Solicitation Addendum

Addendum No.: 4
Solicitation No.: 21-TA003799DJ
Project No.: 6067781
Solicitation Title: Braden Woods Lift Station Upgrade and New Force Main
Addendum Date: September 2, 2021
Procurement Contact: Dave Janney
Senior Procurement Agent

BRADEN WOODS LIFT STATION
REHAB
MANATEE COUNTY
BRADENTON, FLORIDA 34205

JACOBS
PROCESS MECHANICAL
**LIFT STATION
UPPER AND LOWER PLAN**

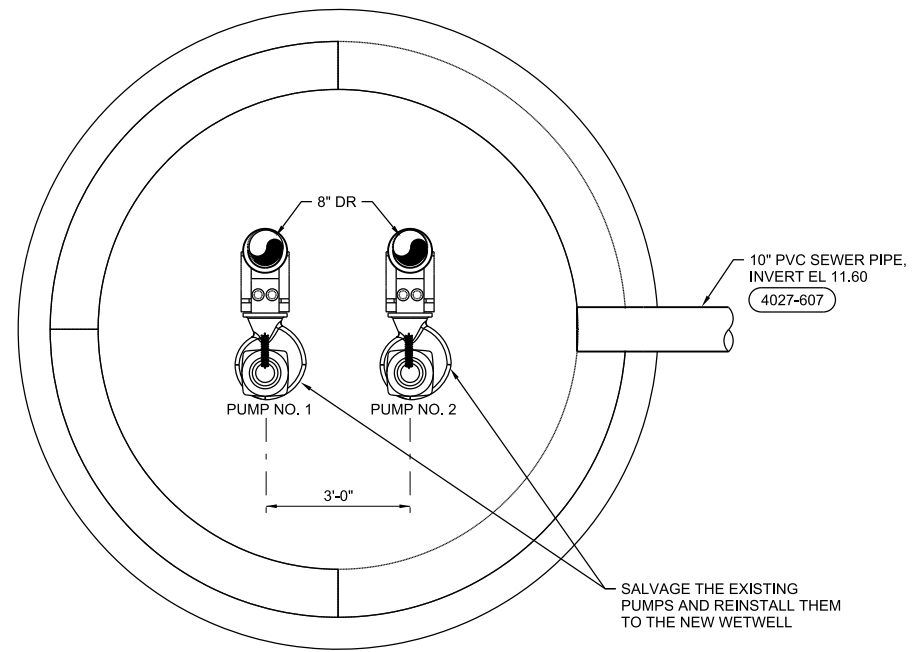
Q1. Referencing the Questions and Responses, page 4 of the addendum, the response to question 10 states, “Typo on detail callout on sheet D-201, revise 0330-0156 to 0330-056. Concrete Pad Type H 0330-056 is shown on sheet S-501”. Detail Type H 0330-056 is not shown on sheet S-501, or any other plan sheet. Please advise.

R1. On Drawing D-201 delete concrete pad callout Type H (0330-156) and replace with (US-19). See updated Drawing D-201 attached.
